J2023-0143
PSP2024-0013
Revision m#3
Received 2/7/2025

City of Rochester
Hills Planning &
Economic
Development

Site Plan Review

SITE PLANS for: PROPOSED GAS STATION

DIMENSION AND LAYOUT PLAN

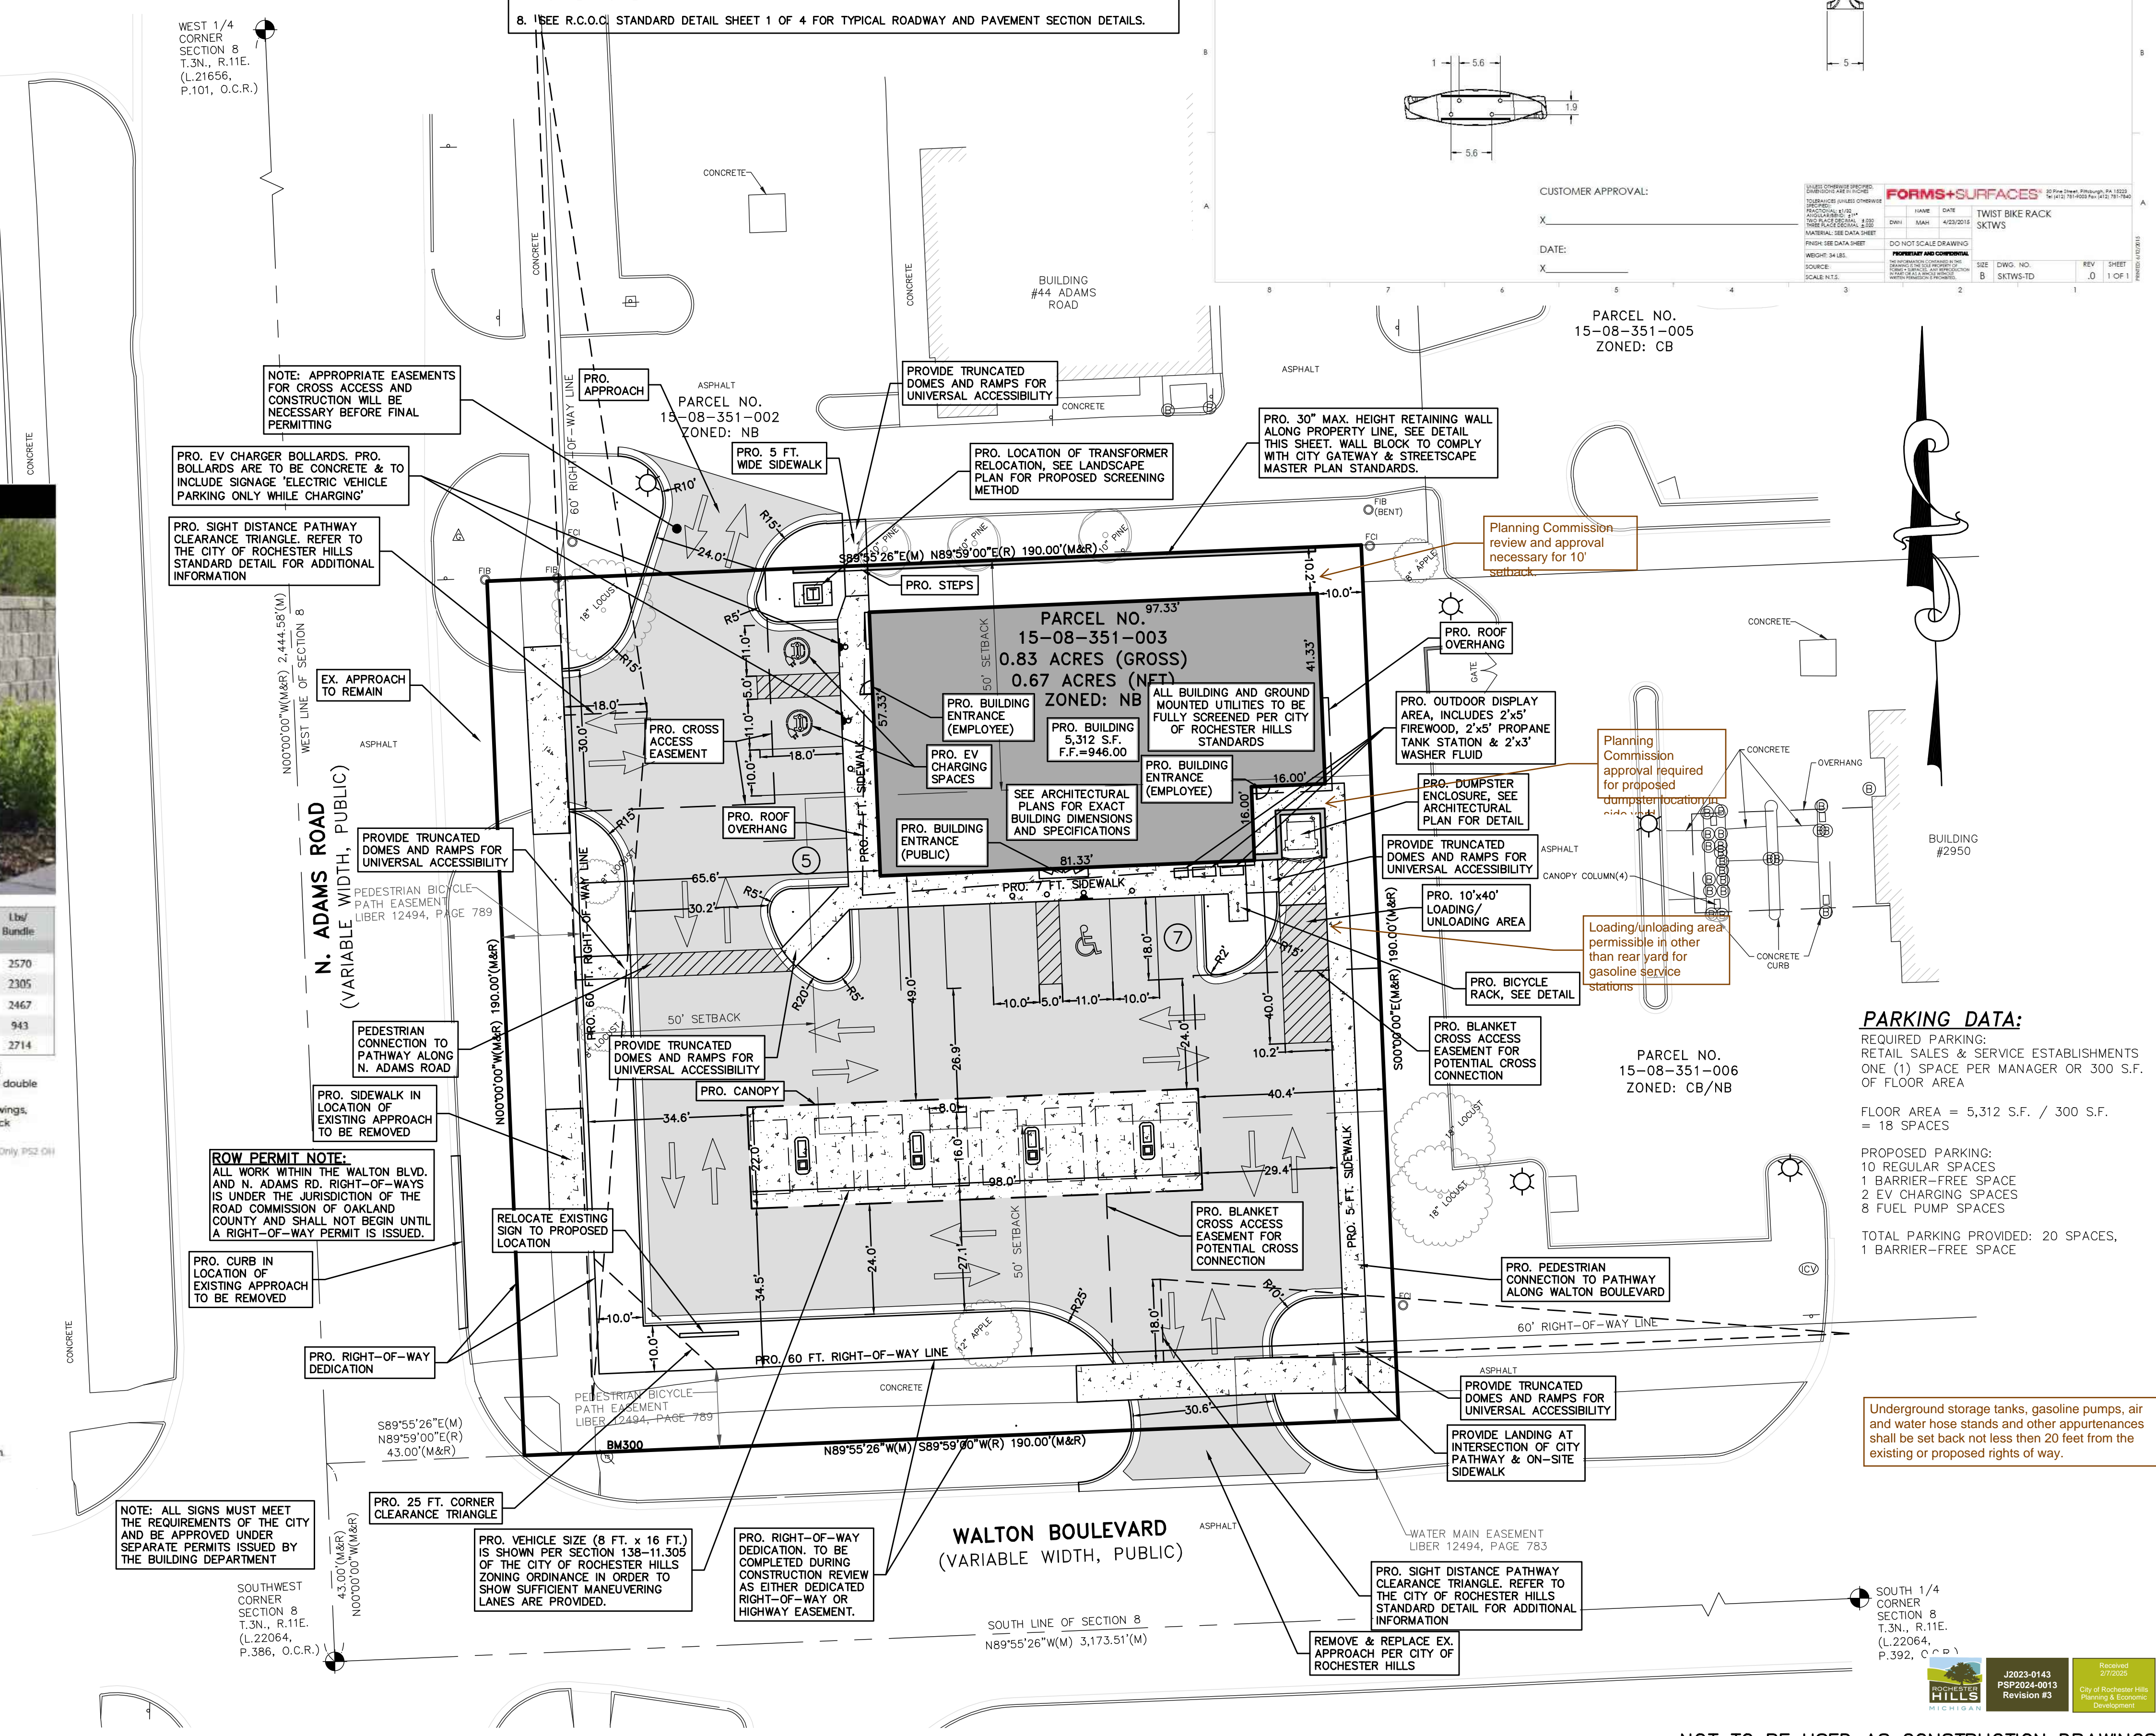
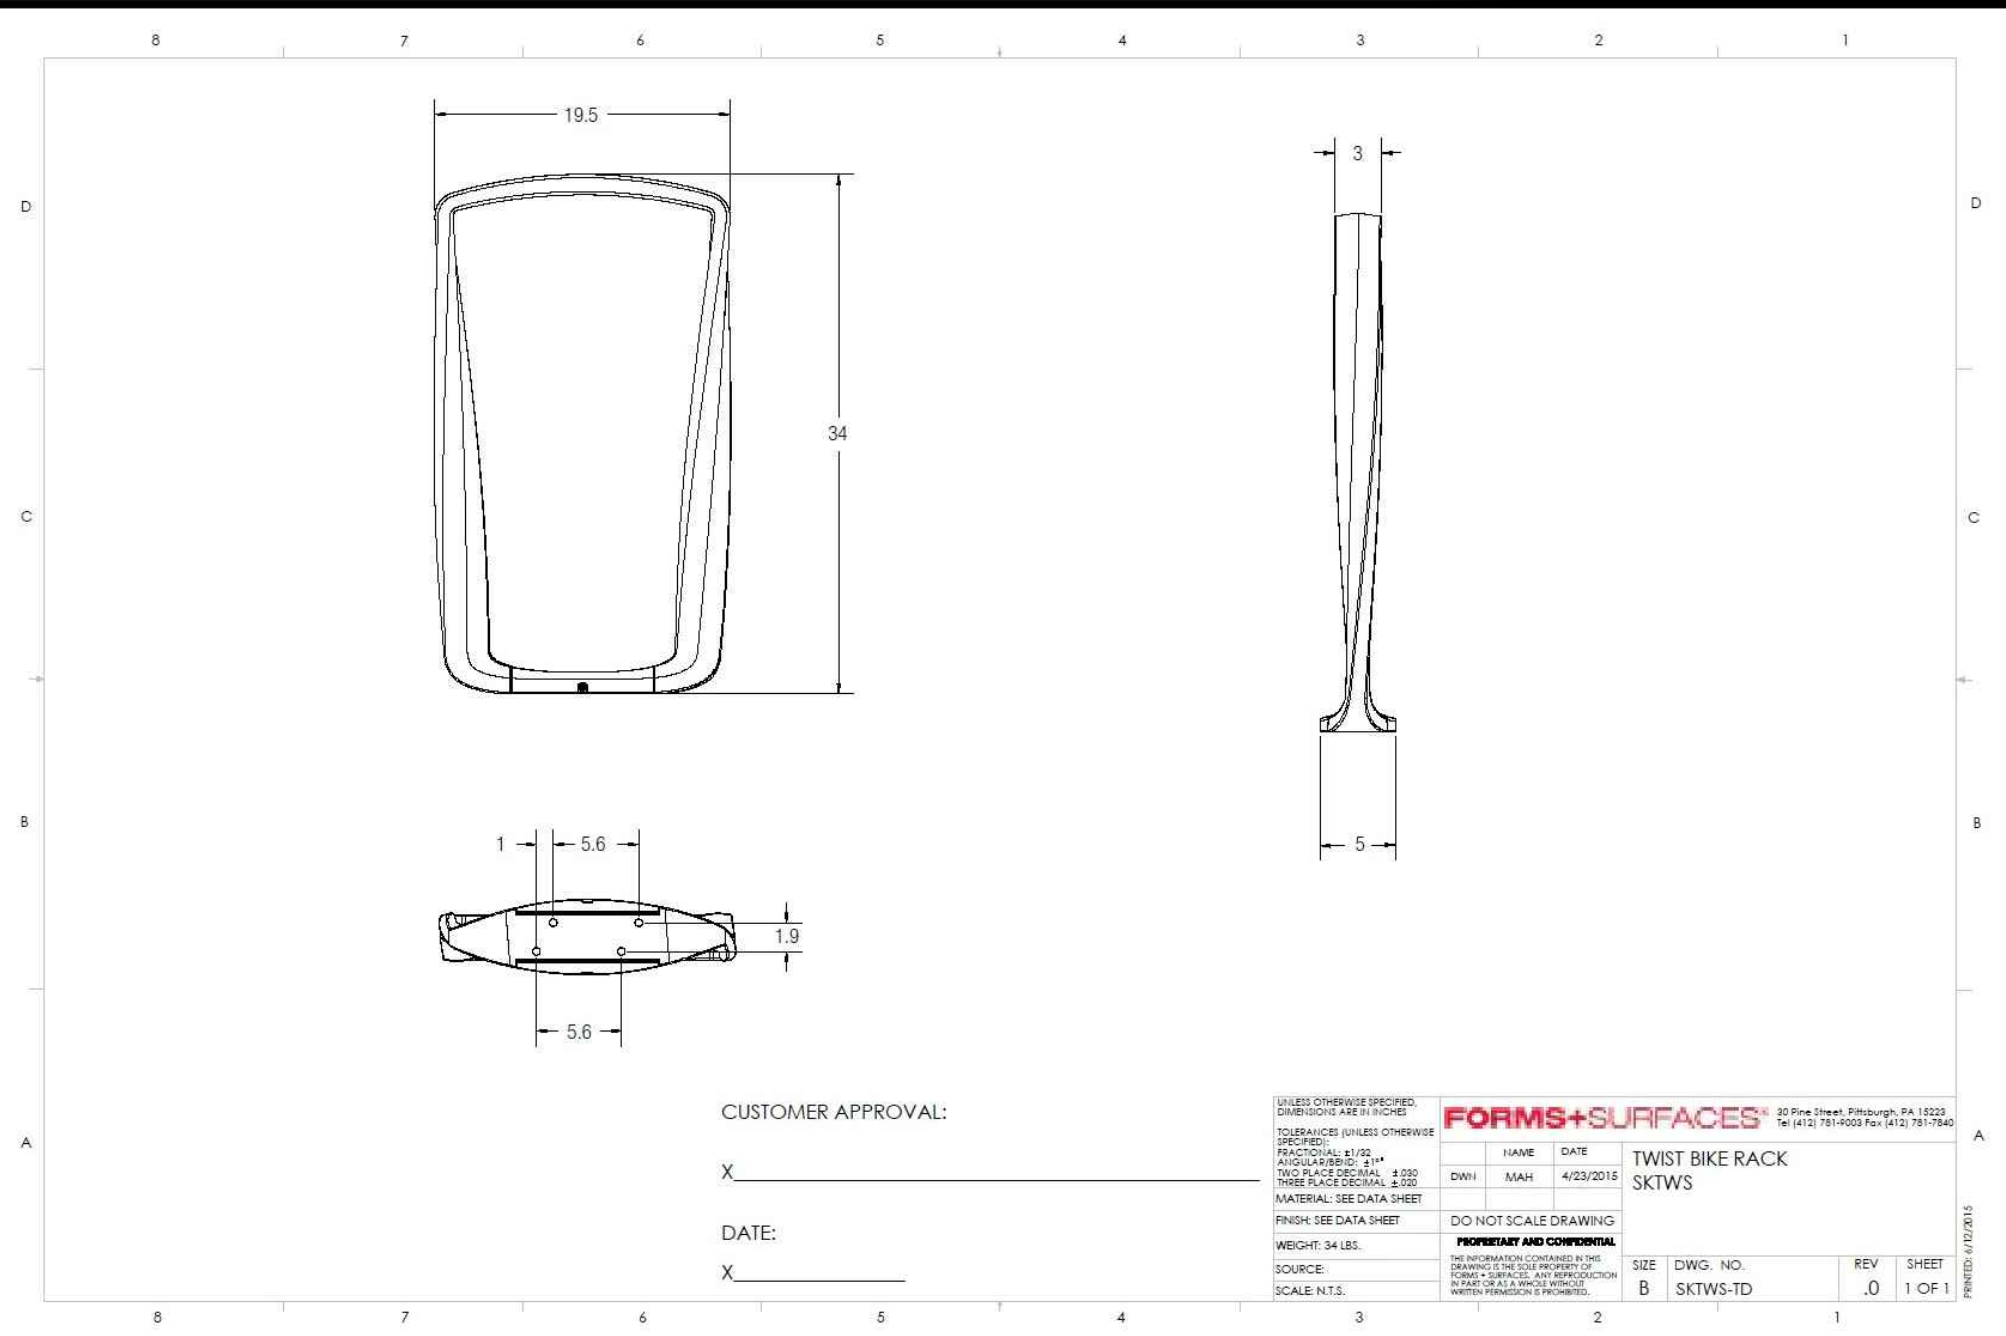
Planning Commission review and approval necessary for 10' setback.

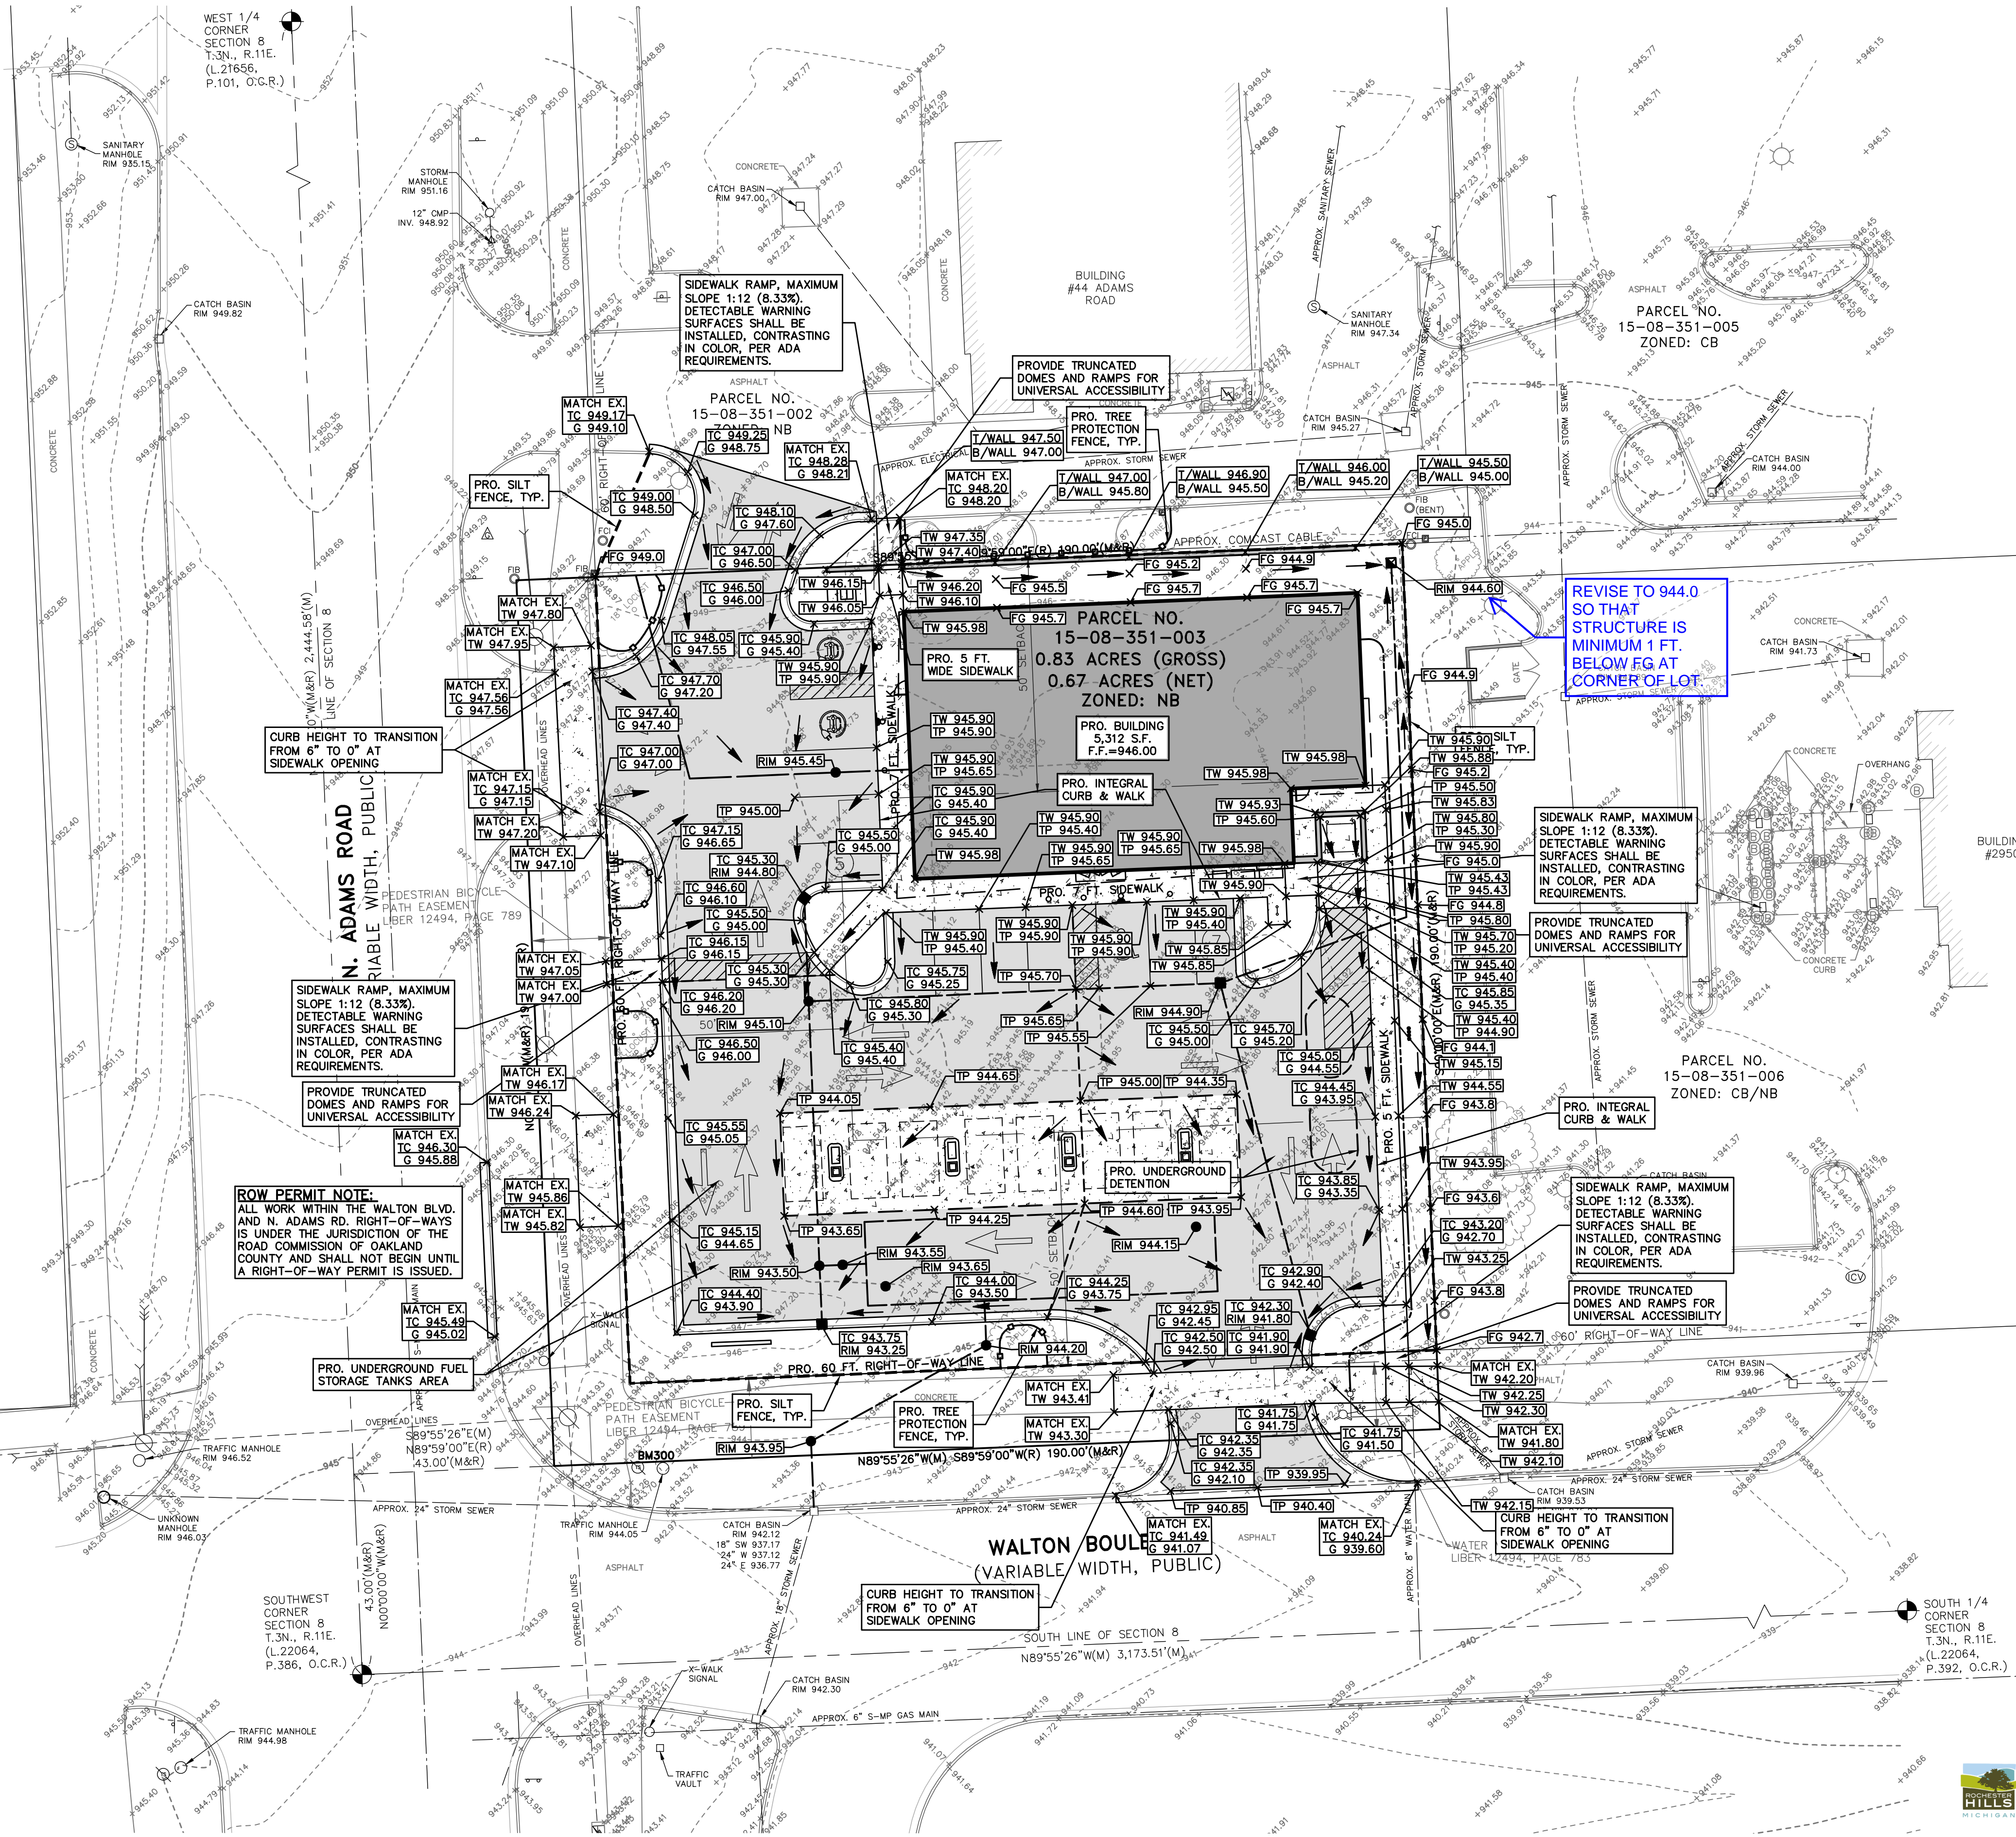
REVISE TO 944.0 SO THAT STRUCTURE IS MINIMUM 1 FT. BELOW FG AT CORNER OF LOT
